Tween Bridge Solar Farm

9.9 Statement of Common Ground with Natural England

Document Reference: 9.9

Revision **12**

Figure 1: 16413_P16a_600m Buffers_TLR_RR

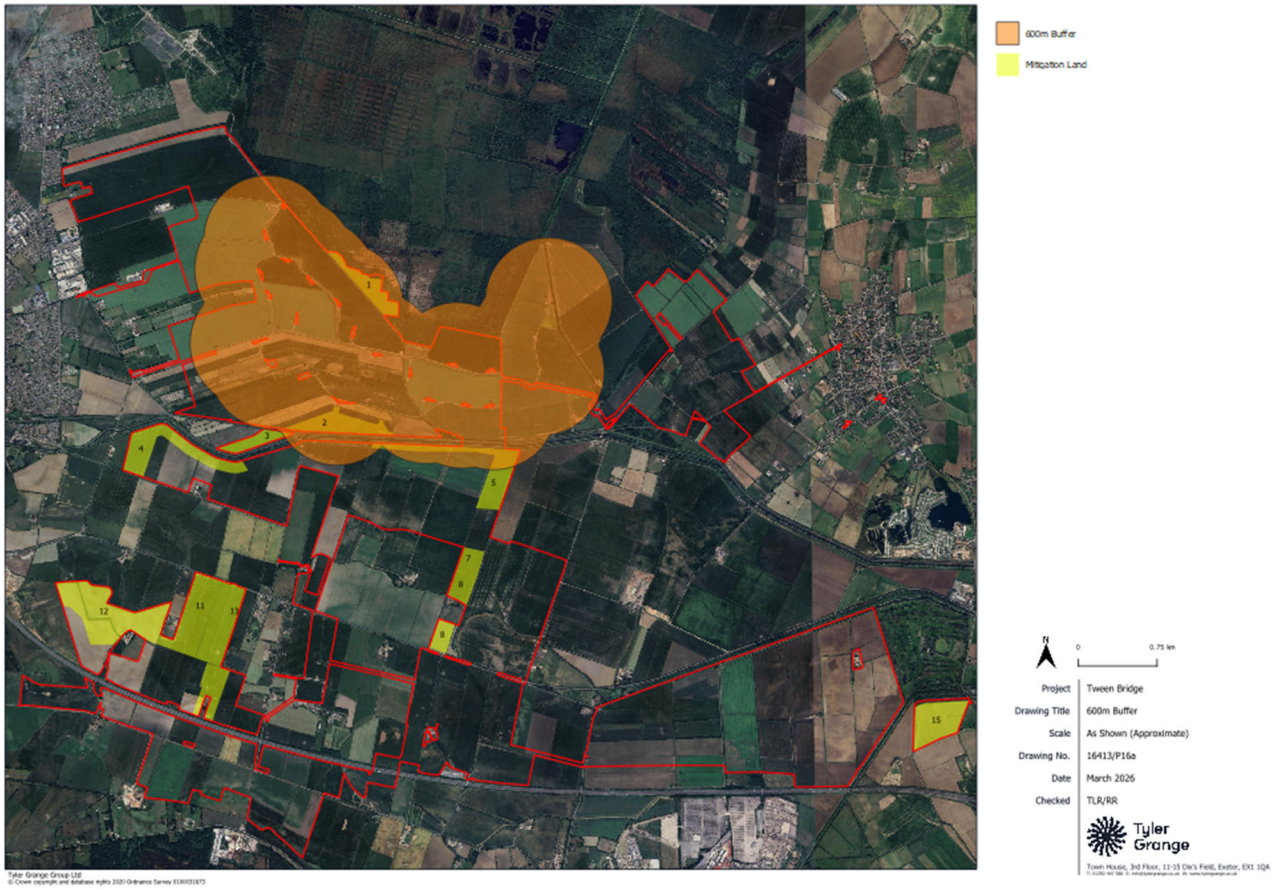
<p>Report to Inform Habitat Regulations Assessment [Document Reference 5.3 Revision 4] and provided as part of Figure 1 within this document.</p> <p>Several mitigation parcels larger than 10ha with at least 150 m open vistas are provided, including M12 and M13.</p> <p>A total of 43.67ha of mitigation land with 150 m open vistas is located beyond 600 m of wind turbines, in line with point NE3 (see below), and is available for lapwing. Bird Days calculations demonstrate that 24.99 ha is required for lapwing (Appendix 2 of the Report to Inform Habitat Regulations Assessment [Document Reference 5.3 Revision 4]), confirming that more mitigation land is provided than required. Additional mitigation land within 600 m of turbines, including parcels M1 and M2, is also available, and lapwing have been recorded using these areas, therefore ensuring that additional land is available for this species.</p> <p>When considering mitigation land beyond 600 m of turbines_108.84ha</p>

<p><u>Has the removal of the M1 parcel has been factored in to the total?</u></p> <p><u>If M1 is the area to be removed from the mitigation strategy - it must be</u></p>	<p>to reflect bird use where possible. Given the mobility of SPA bird species, and the location of the Order Limits approximately 7.7 km from the Humber Estuary SPA, birds will utilise suitable habitat across a large area. This is supported by non-breeding bird survey results that show use of the Order Limits changed between the survey periods, although also show notable lapwing use in the northern part of the Order Limits close to proposed mitigation areas.</p> <p><u>The Applicant confirms that the parcel M1 is not proposed to be removed, rather it is proposed to be reduced in extent and would therefore continue to perform a mitigation function for breeding and non-breeding birds. Nonetheless, as detailed in Table 1-1: Non-Breeding Bird Mitigation Land Calculations at the end of this document, the mitigation calculations do not include parcel M1 due to its proximity to wind turbines</u></p>

<p><u>demonstrated how this will be accounted for.</u></p> <p><u>Could clarification be provide as to whether this is in addition to the above 43.67ha? Aware this will likely be set out further in the mitigation strategy</u></p> <p><u>We confirm this remains under discussion - We acknowledge further details of the proposed approach but as discussed in call on 24 February - we will need to see the updated mitigation strategy accounting for suggested changes and demonstrating in full the carrying capacity</u></p>	<p><u>The Applicant confirms that as seen in Table 1-1: Non-Breeding Bird Mitigation Land Calculations at the end of this document, that the calculations do not include parcel M1 and the figures provided demonstrate there is sufficient mitigation land, based on using Bird Days calculations and the habitat requirements and ecological knowledge of the species being mitigation.</u></p> <p><u>The Applicant confirms that 108.84ha is in addition to 43.67ha.</u></p> <p><u>As detailed in Table 1-1: Non-Breeding Bird Mitigation Land Calculations at the end of this document, and shown in Figure 1: 16413_P16a_600m Buffers_TLR_RR, at the end of this document.</u></p> <p><u>The Applicant confirms that reducing in extent parcel M1 would not affect the mitigation strategy and that sufficient mitigation is provided</u></p>

<p>location, and whether this would impact the functionality of the mitigation.</p> <p>Natural England advises that a precautionary buffer of 600m should be used when assessing the predicted extent of displacement from wind turbines. Further assessment should be carried out within the recommended 600 m buffer zone to determine the predicted level and effects of displacement, informed by site-specific factors such as the habitats available, extent and type of bird usage within the buffer zone, relative importance of the area and existing pressures on the species present.</p> <p>Natural England advises that displacing birds on a continuing basis from areas used for all necessary stages of the non-breeding period equates to effective habitat loss, as such habitat is no longer 'available'. Should it be determined that the functionality of the mitigation areas would be adversely impacted, alternative sites should be considered.</p> <p><u>Cannot locate figure - Please provide further details</u></p>	<p>email correspondence dated 10.07.2025 – see Appendix 1), and which have been completed in addition to ecological knowledge of the carrying capacity of different habitat types, <u>which is also in line with Natural England's correspondence when they state that ecological knowledge should supplement the bird days calculations to demonstrate that there is suitable habitat provision for the numbers of birds displaced by the development.</u></p> <p><u>The Applicant confirms that Figure:16413_P16a_600m</u></p>

<p><u>As stated in email in Appendix, although an NE ornithologist confirmed that the calculations look fine, NE doesn't have a nationally recognised method of using bird days in this way within terrestrial ornithology. We highlighted that as mentioned previously, ecological knowledge should supplement the calculations to demonstrate that there is suitable habitat provision for the numbers of birds displaced by the development.</u></p> <p><u>Request these clarifications are provided here.</u></p> <p><u>We confirm this remains under discussion - We welcome that some additional detail has been provided here, however, we request that further assessment in updated documents including details of potential displacement impacts and increased collision risk.</u></p>	<p><u>Buffers_TLR_RR is attached at the end of this document.</u></p> <p><u>The Applicant confirm that the use of ecological knowledge has been used to supplement the bird days calculations to demonstrate that there is suitable habitat provision for the numbers of birds displaced by the development..</u></p> <p><u>The Applicant confirms that further detail on monitoring for collision risk is included in the Outline Landscape Ecological Management Plan [Document Reference 7.6 Revision 3] submitted at Deadline 2.</u></p>
